Riddolls Consultants Ltd

Mr John Edgar,
Community Liaison Group - Huia Water Treatment Plant Replacement,
AUCKLAND

GEOLOGICAL INFORMATION: COMMENTS

5.3 Manuka Road site

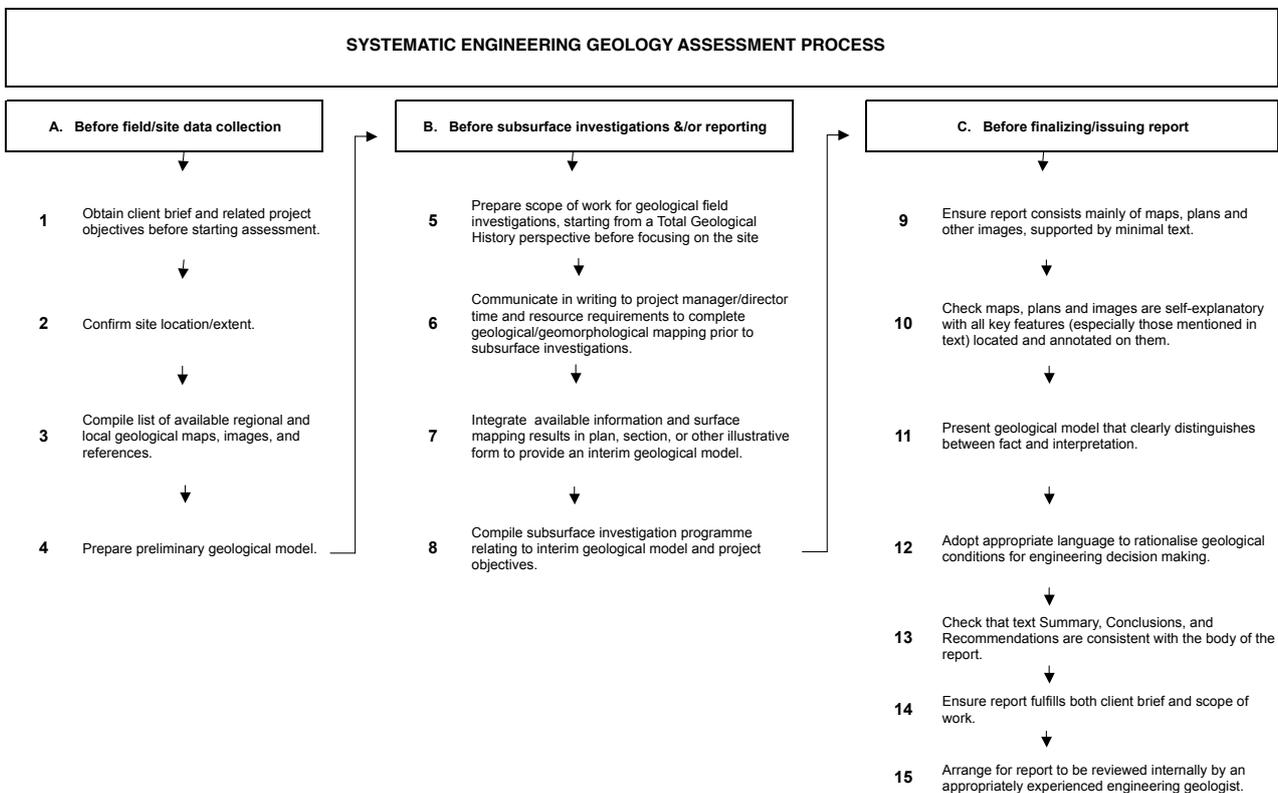
A recent study¹⁰ describes the site topography as “lobate, being areas of uneven back tilted ground, that is suggestive of large scale land instability”.

Also noted¹⁰ is “colluvial soil related to slope movement at depths of 3-8 m across the site posing “a risk of instability due to future development, from loading the ground, or removing the toe support”.
